# Backfeed in a 4-pair context

Version: V1.2(20180518)

***Change 145.3.8.8 (backfeed\_d3baselinep4.pdf , version v230)as follows:***

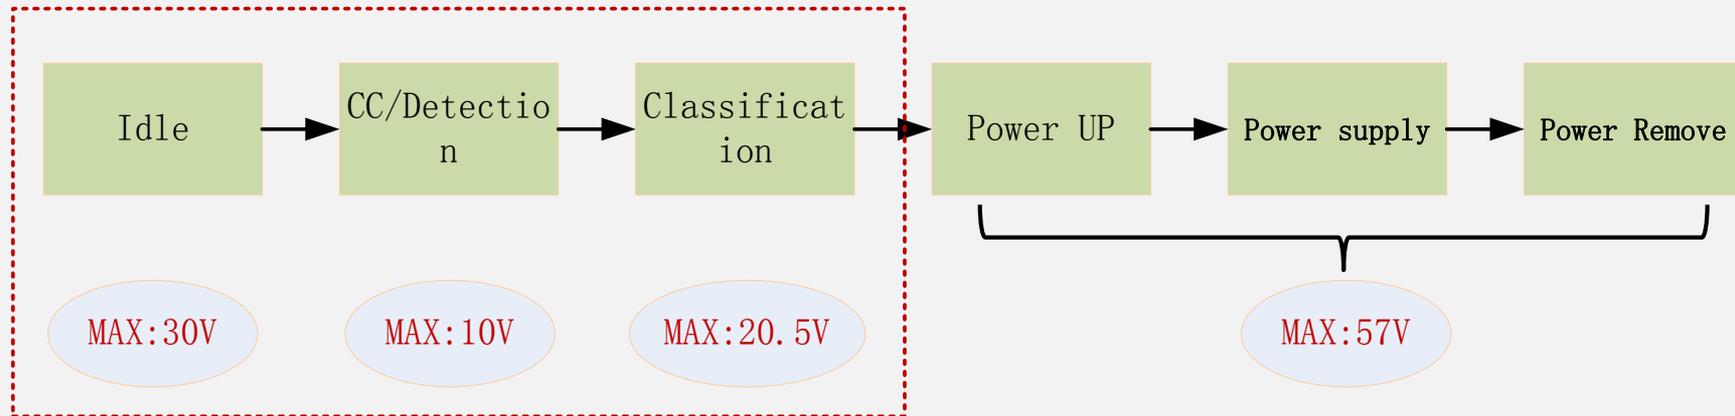
For a single-signature PD, when any voltage in the range of 0V to VPort PD-2P max is applied per any of the valid 2-pair configurations, defined in Table 145–20, that have only a single pair connected to positive VPSE, the voltage on the Mode not connected to the voltage source, with a 100 kΩ resistor connected across that Mode, shall not exceed Vrefl as defined in Table 145–29.

For a single-signature PD, when any voltage in the range of 0V to ~~10.1V~~ 21V is applied per any of the valid 2-pair configurations, defined in Table 145–20, including those with two pairs connected to positive VPSE, the voltage on the Mode with at least one pair not connected to the voltage source, with a 100 kΩ resistor connected across that Mode, shall not exceed Vrefl as defined in Table 145–29.

For a dual-signature PD, when any voltage in the range of 0V to VPort PD-2P max is applied per any of the valid 2-pair configurations, defined in Table 145–20, including those with two pairs connected to positive VPSE, the voltage on the Mode with at least one pair not connected to the voltage source, with a 100 kΩ resistor connected across that Mode, shall not exceed Vrefl as defined in Table 145–29.

Figure 145-19—PSE detection source

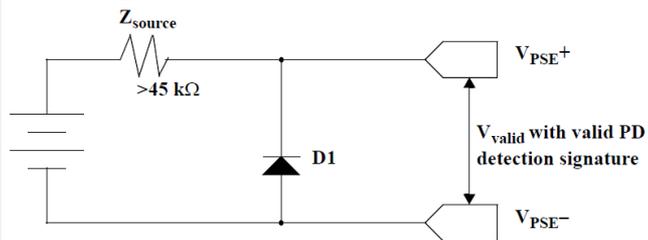
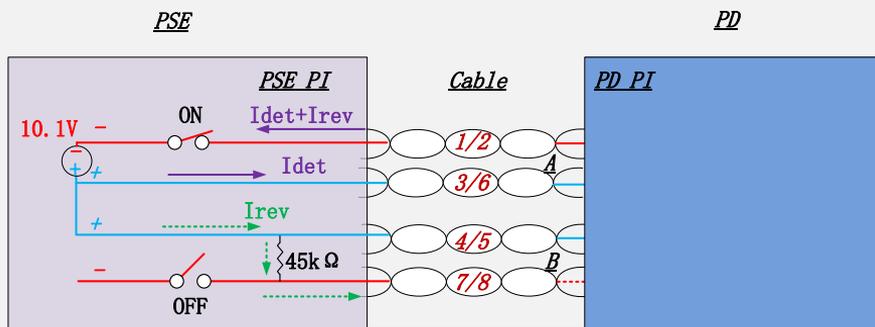
Vrefl will lead to Zsource parallel to Rsig.

Rsig=19kΩ is Accept signature resistance. Rsig in parallel to Zsource is Reject signature resistance

$19\text{k}\Omega * 45\text{k}\Omega / (19\text{k}\Omega + 45\text{k}\Omega) = 13.359\text{k}\Omega \rightarrow$  **Reject signature resistance**

**Solution:** The voltage for single-signature PD should be **at least 10.1V**

Table 145-13—Class signatures evaluated at the PSE PI

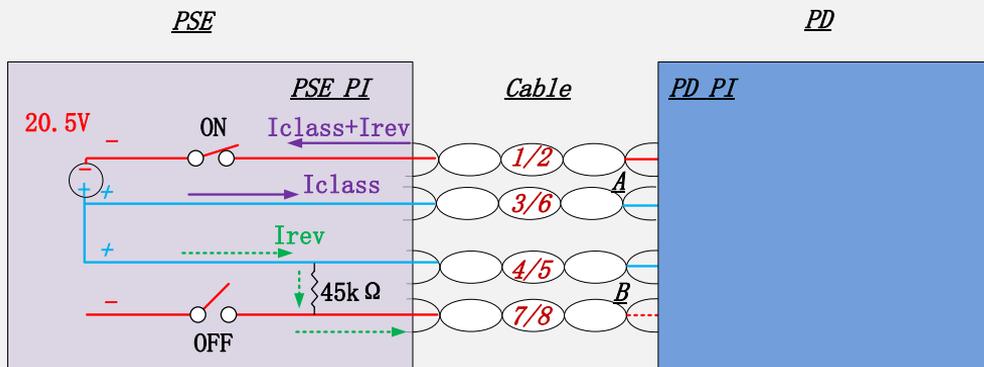
Classification current may be changed by  $20.5\text{V}/45\text{k}\Omega=0.456\text{mA}$  (or  $I_{rev}$ ), which requires higher accuracy measurement.

The margin between class 0 to class 1 and class 1 to class 2 will be reduced to  $2.544\text{mA}(3\text{mA}-0.5\text{mA}=2.5\text{mA})$

**Solution:** The voltage for single-signature PD should be **at least 21V**. (preferred 30V, to be discussed)
